Tottenham House and Estate

Walled Garden Landscaping

Design & Access Statement – NMA Application

28th August 2026

Figure 11 – Proposed new Landscape Layout incl. Buildings

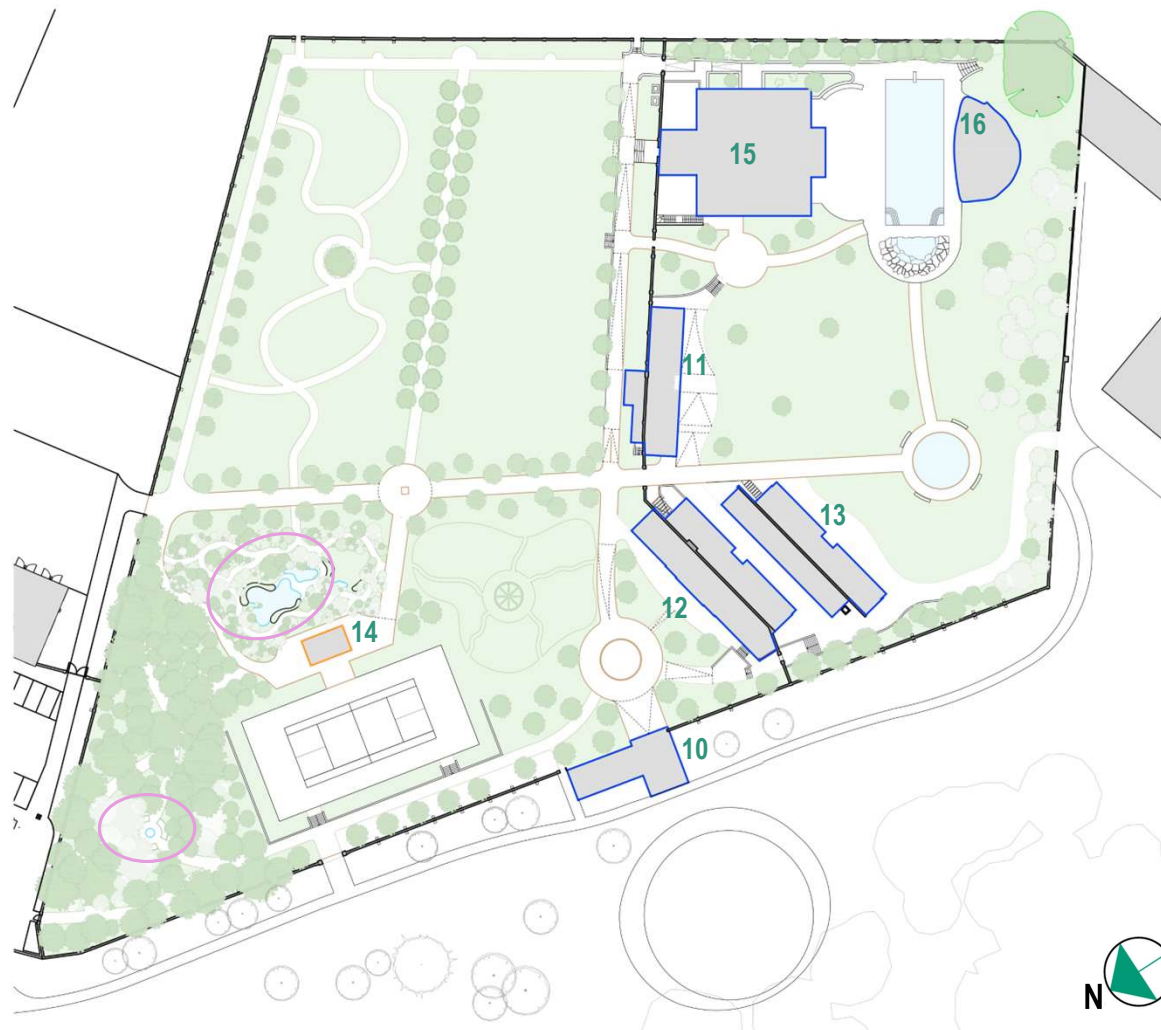
Fig. 11 The changes to the Walled Garden Landscaping from the consented scheme are:

- the reduction of the tennis courts to one court, in the same location, the main reason behind the change was to increase the space for more planting and create more screening and privacy around the court
- the substitution of the octagonal tennis pavilion for a larger Chinese-inspired building (No.14), the main reason for this change not only to increase service spaces to the Tennis Court but also as a reference to similar building present in other historical gardens

- Additional serpentine paths
- Additional water features
- Changes to the soft landscaping
- Circular planting space between buildings 10 & 12 to improve circulation

5.7 Consented (fig 12) & Proposed Walled Garden Landscape (fig 13) Layouts

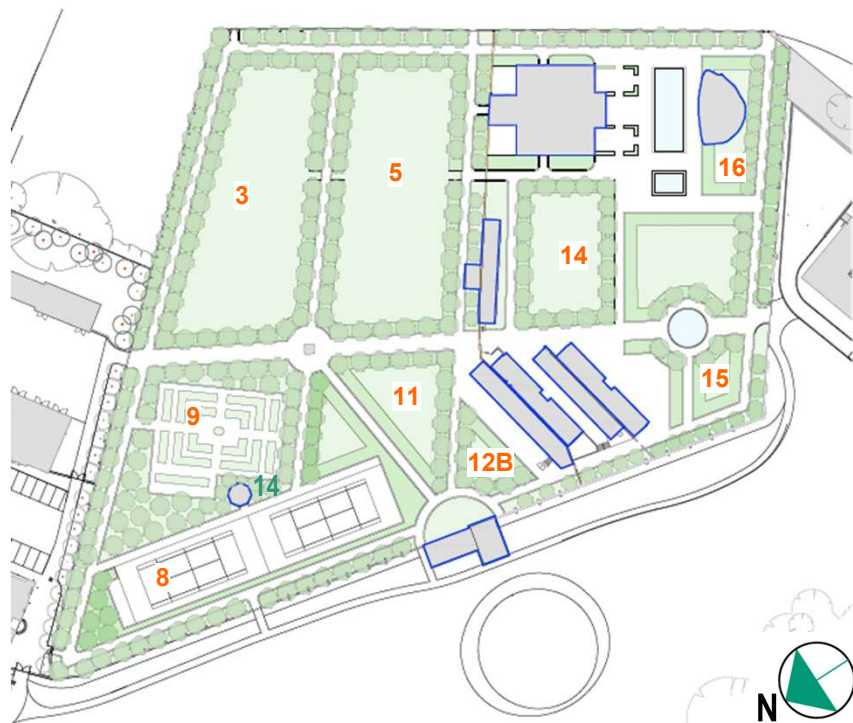
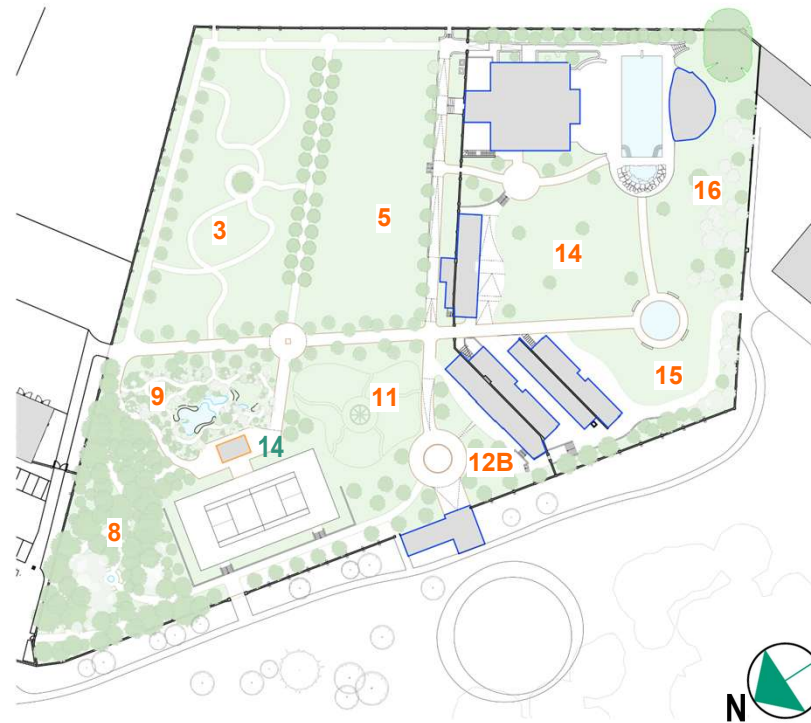
AREA 3 - Additional serpentine paths

AREA 5 – no changes

AREA 8 – 1No. Tennis court omitted to increased area for planting

AREA 9 – formal planting replaced by natural ponds and planting, better for wildlife

AREA 11 – pathways altered and increased area for planting

AREA 12B – circular planting area introduced for better circulation

AREA 14 - Additional serpentine paths & reduced formal planting

AREA 15 - Paths revised to more fluid shape & reduced formal planting

AREA 16 – Formal paths omitted, increased area for planting

ITEM 14 – Revised design of Tennis Court Pavilion, Building 33

6.3 Building No 33 – Tennis Court Pavilion – proposed new design

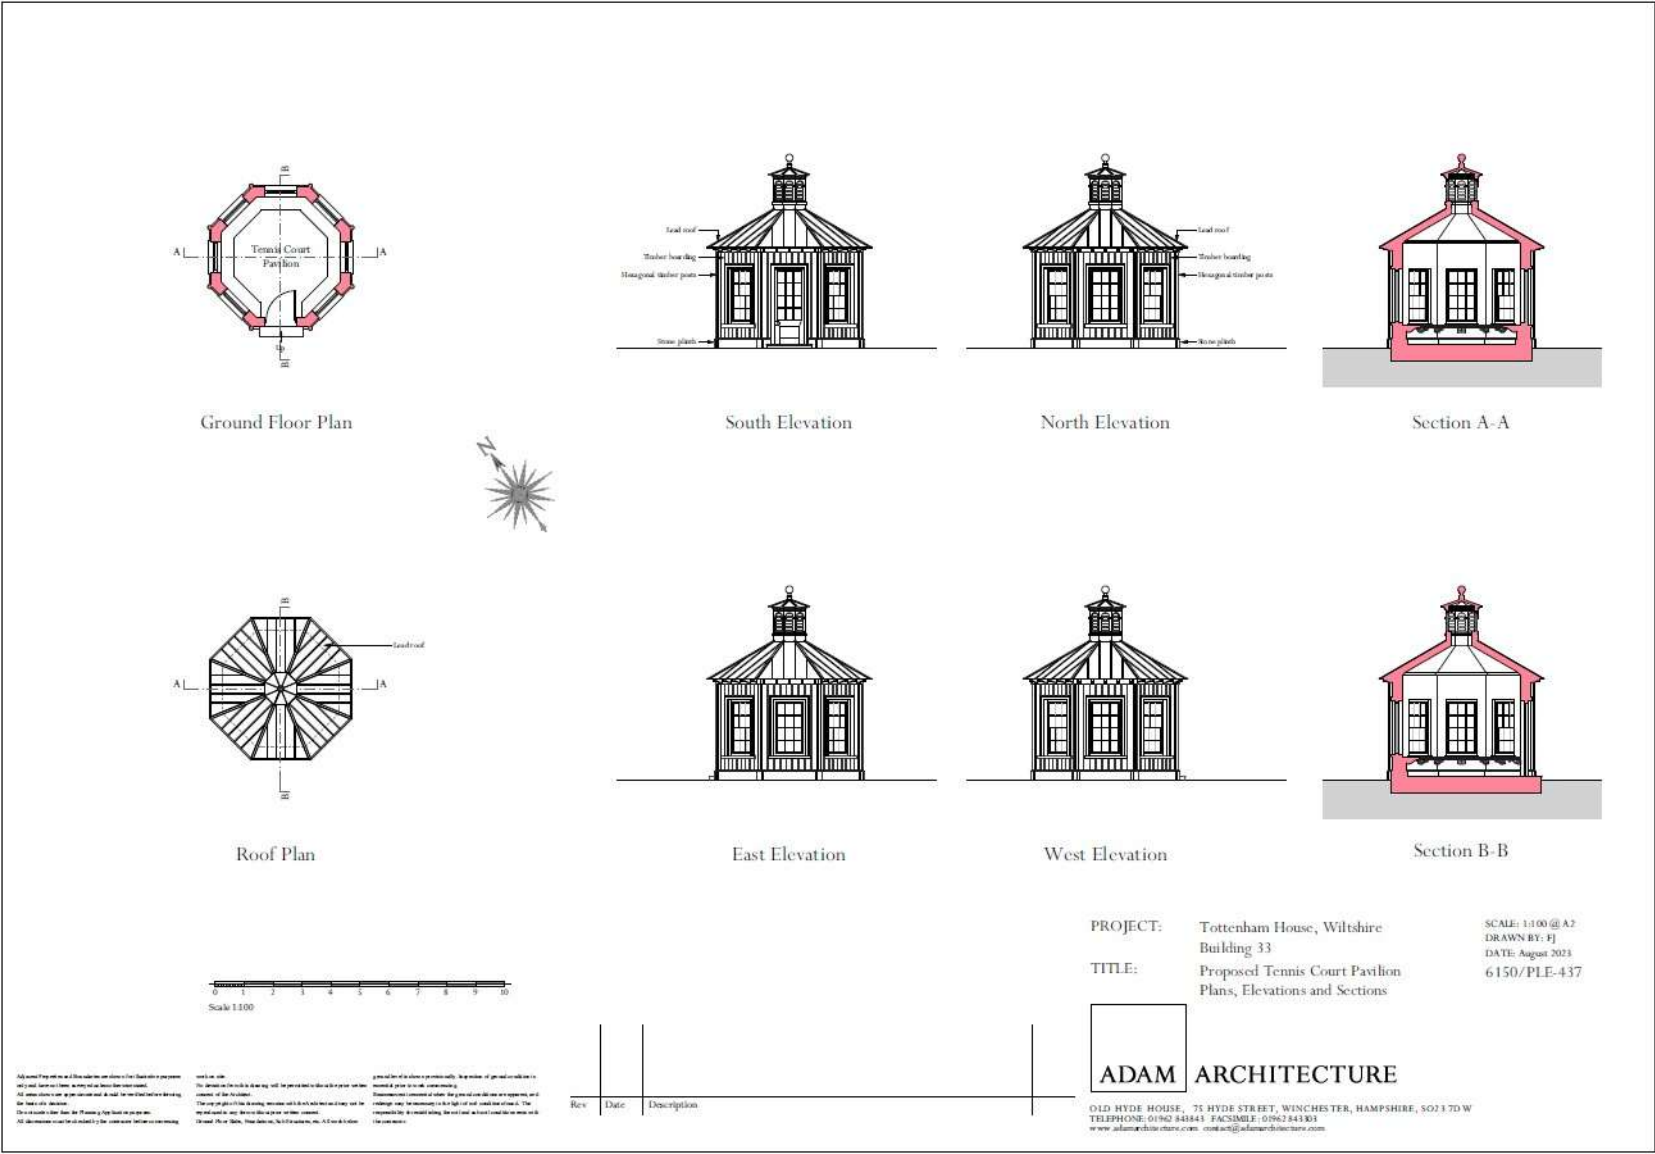
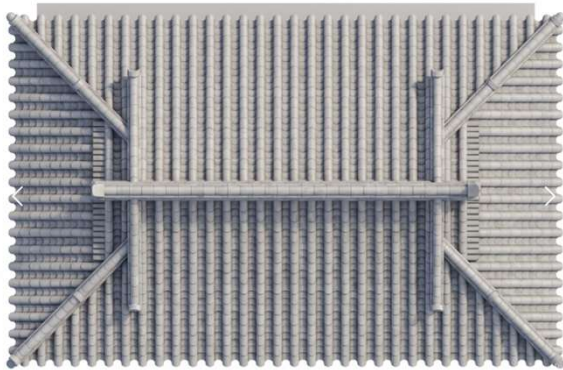
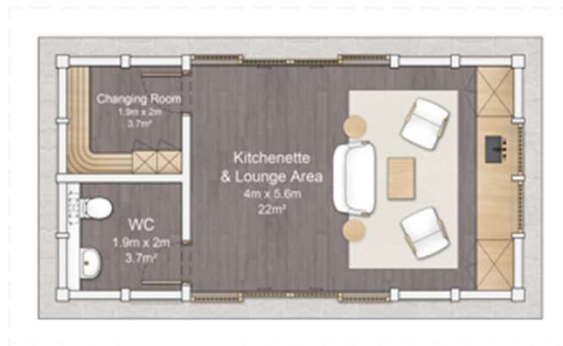
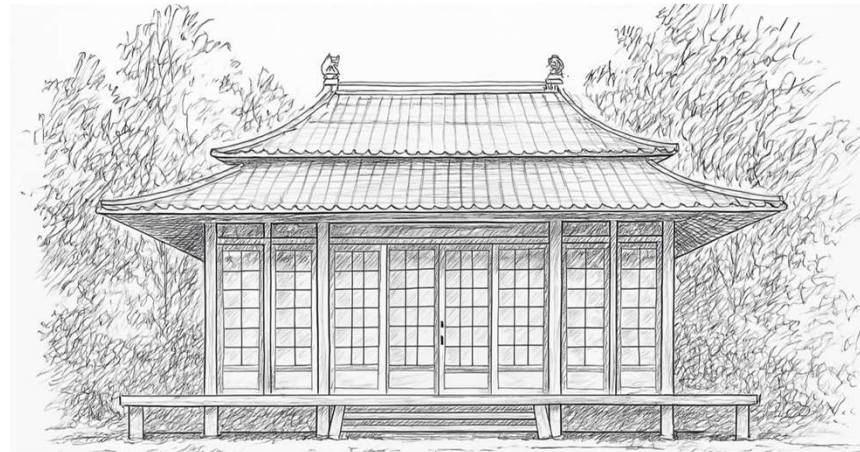
2.3 Changes to the consented Walled Garden Tennis Court Pavilion (building 33)

The Tennis Court Pavilion (Building 33) proposed by Adam Architecture has been approved and consented for the current masterplan ref 17/12461/ OUT and 18/00195/LBC and was retained in the BLDA scheme consented, ref PL/2024/09312

The proposed revised design of the larger Chinese-inspired building is not only for practical reasons (providing further service spaces to the Tennis Court) but also as a reference to similar building present in other historical gardens **such as the Chinese House (1783) at Stowe, the Ranelagh Gardens Chinese Pavilion (added in 1750 and demolished in 1805), the 19th century Chinese inspired buildings in Whaddon House, & the pagoda at Kew Gardens (designed by William Chambers in the 1760s) Refer to examples on page 16.**
